RE: **Clarksburg Town Center - Perimeter Road Sections**

DATE: January 7, 1998

DPW&T/DPS (Transportation) Recommended Typical Sections

### Summary of Points on Perimeter Road Sections

## CTC PRELIMINARY PLAN SECTION ALT. No. 3

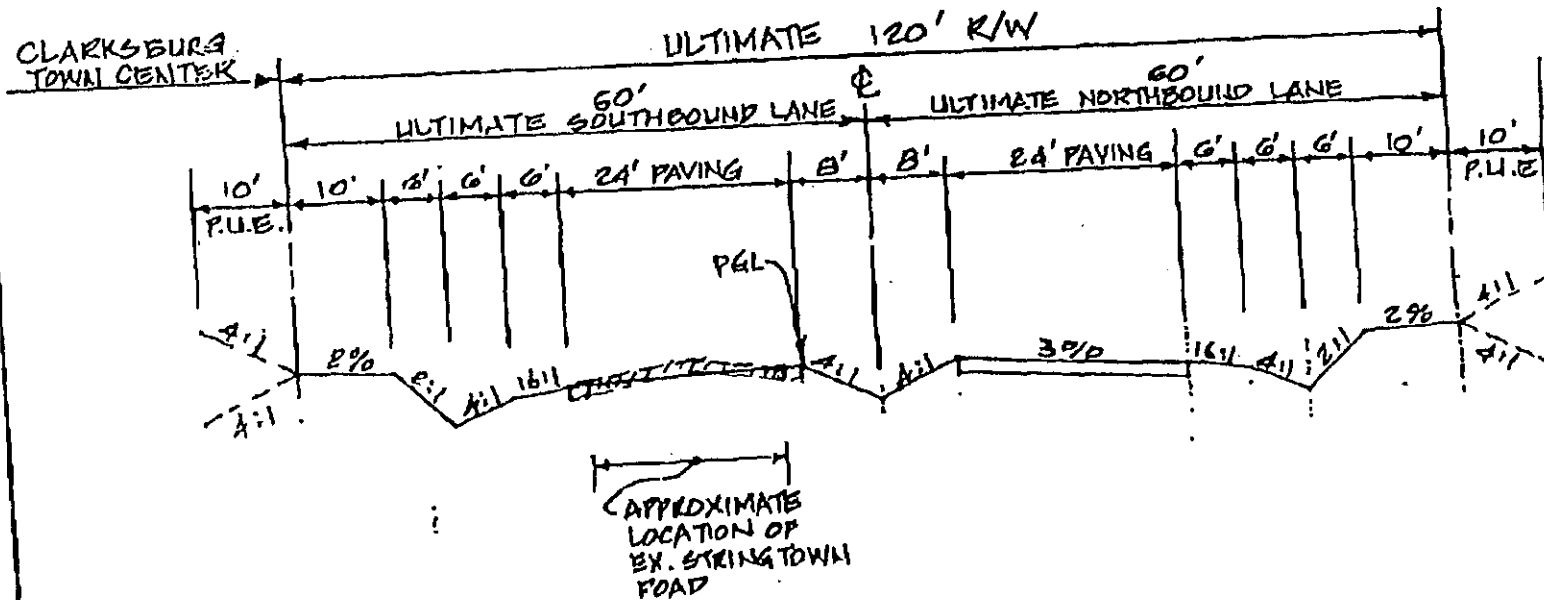
If the agencies desire to attempt to save portions of the hedgerow, without a retaining wall, along Clarksburg Road, we suggest that they consider adopting the attached cross section diagram, which removes the bikeway, which would be acceptable to the Town Center (Exhibit A). It was also noted on the road net diagram that was provided to us at the recent December 9 meeting that the bikeway/sidewalk was removed from the cross section along the entire frontage of the park/school property as well.

\*\*This diagram is solely to illustrate a possible change to the section so as to try to save portions of the hedge row.

## STRINGTOWN ROAD

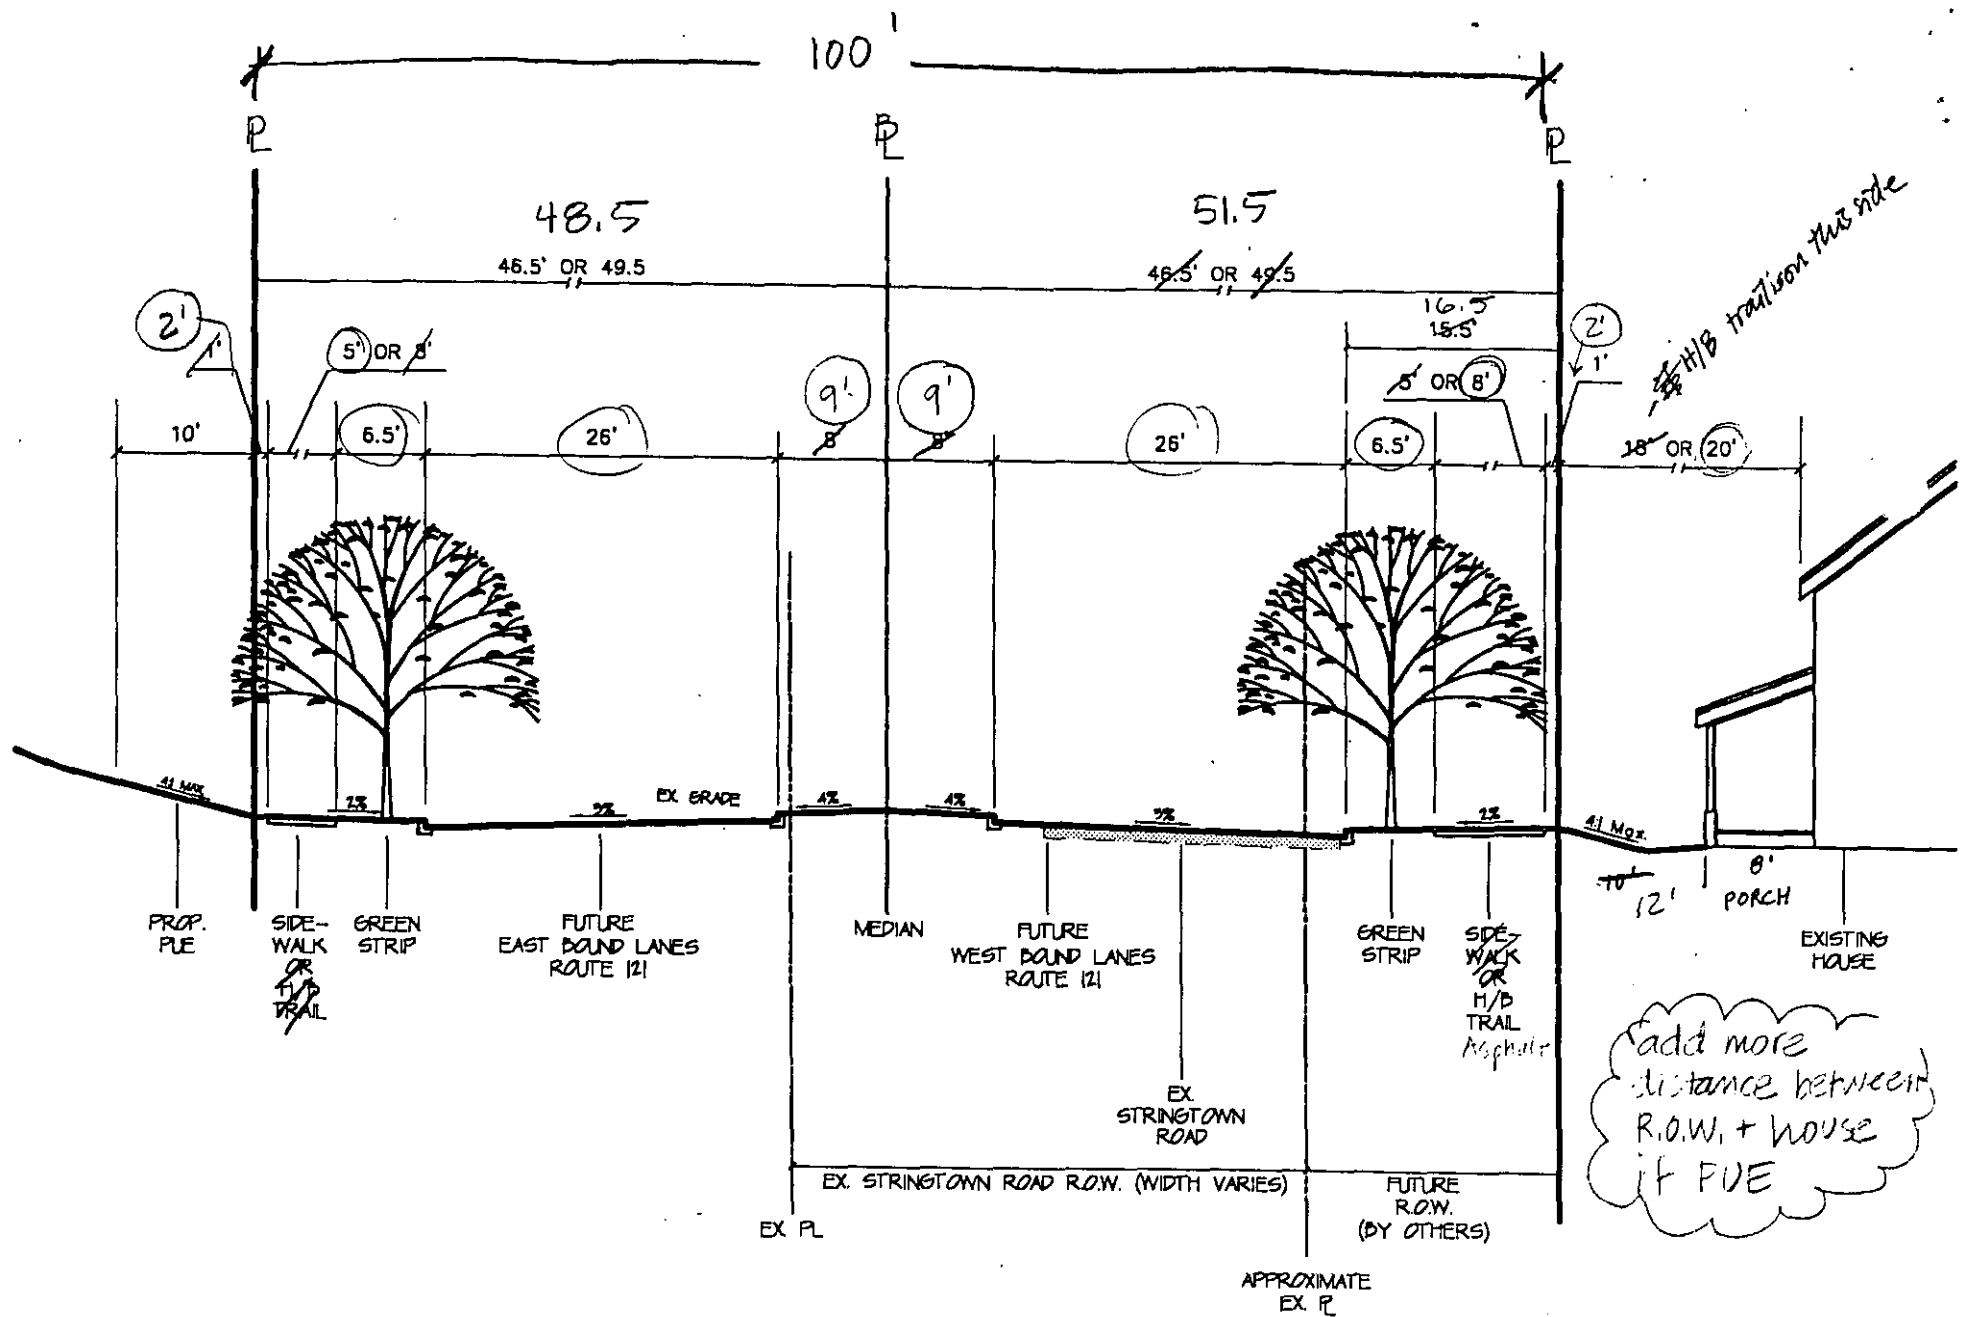
The curbing on the inside is to be built by others in the future when the entire median is built. The Town Center was required to widen the existing paving to 24 feet as described as "safety improvements." The attached diagram that was presented to all agencies at the time of preliminary plan review is attached hereto. Bikeway is to be constructed only along our frontage instead of a sidewalk.

As pertains to A-260, attached as Exhibit B is the section diagram that was approved at the time of Preliminary Plan Approval. Except for that portion of the alignment No. 2 that diverged from the existing roadway, the Town Center was only required to widen the existing roadway to 24 feet for "safety improvements." The Town Center cannot afford to do more in this area than it agreed to do. To suggest that the pavement should be widened to add a bikeway when the bikeway obligations were clearly established at Preliminary Plan is, in our opinion, not fair. We are agreeable to replacing the sidewalk with an 8-foot bikeway only along our frontage and the new section of A-260 when ROW is made available.

# STRINGTOWN RD. CROSS SECTION

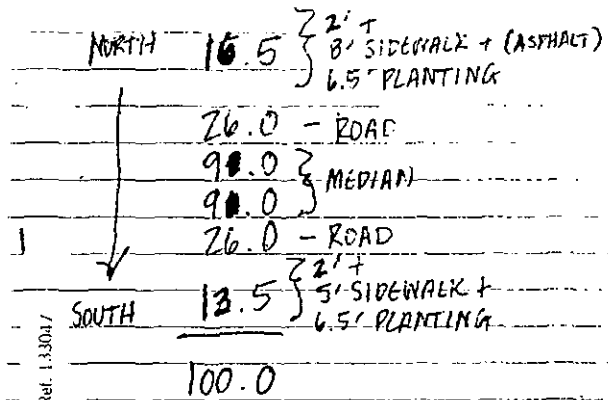
not redrawn but... marked up per 12/4/97 meeting
